Technical Service Bulletin

Cobra Motorcycle Mfg.

TSB0910 Clutch Arbor and Washer Spacer

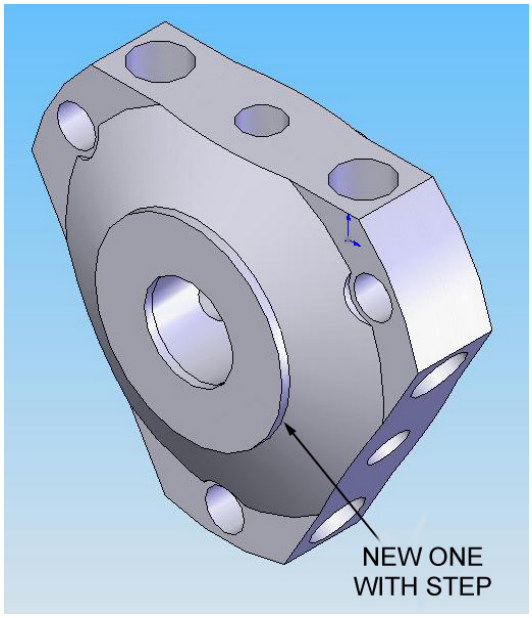
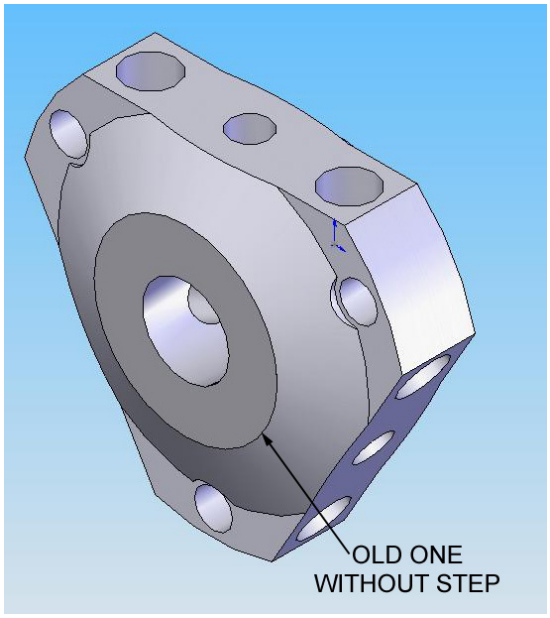
Cobra has changed the geometry of the clutch arbor to eliminate the spacer washer (HCWS1016) behind the kick start nut. Old and new style arbors are shown below. Do not use the HCWS1016 with the new style arbor. Old and new style arbors have the same part number CCMU0029
